**FLOODWAY DEVELOPMENT PERMIT #851-24-00518-PLNG
SELBY/SPATH**

March 19, 2025

- Request:** A review of a Floodway Development Permit for the placement of a proposed single-family dwelling near the Nestucca River.
- Location:** The subject property is accessed from Airport Way, a local access road, and is designated as Tax Lot 6000, of Section 30BD of Township 4 South, Range 10 West of the Willamette Meridian, Tillamook County, Oregon.
- Zone:** Pacific City/Woods Medium Density Residential (PCW-R2) Zone
- Applicant:** Ian Spath, 34635 Hill Street, Pacific City, OR 97135
- Property Owner:** Howard & Mary Selby, 8714 NW Lakeshore Ave, Vancouver, WA 98665

FIGURE
3

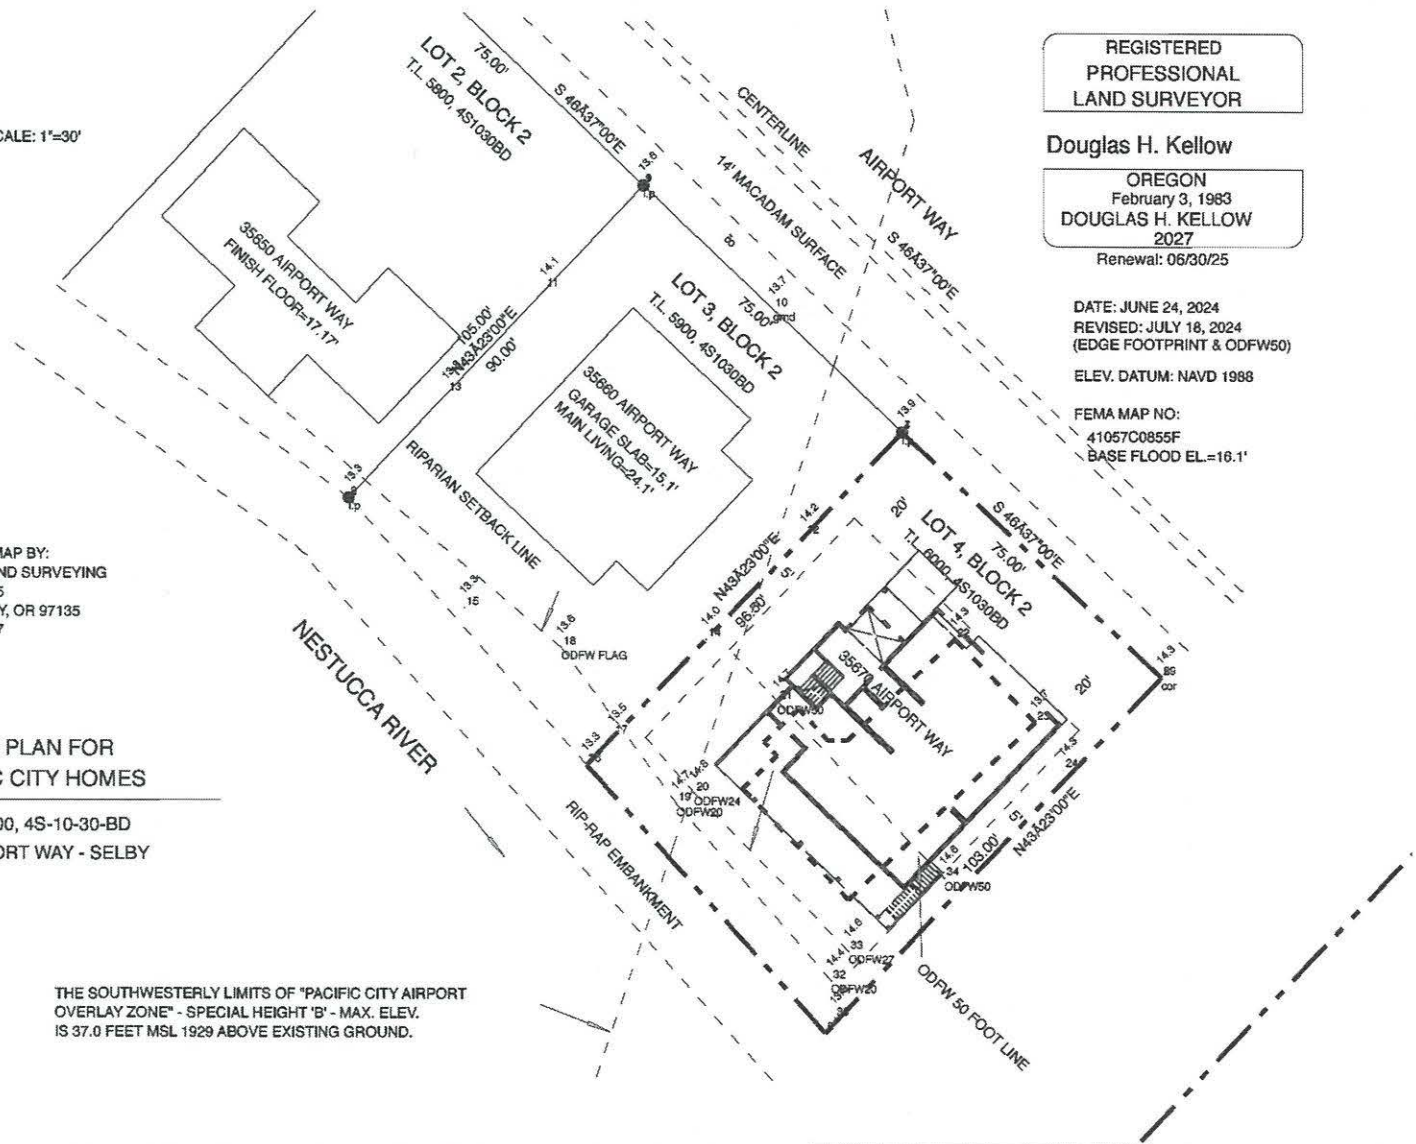
If you look at Figure 3 of the Property Survey and Site Plan (and on Sheet 2 of the home plan in upper left corner) , it shows the 50 foot line going through the middle of the proposed house (labeled ODFW50). It also shows the existing setback (ODFW24) and the minimum setback (ODFW20).
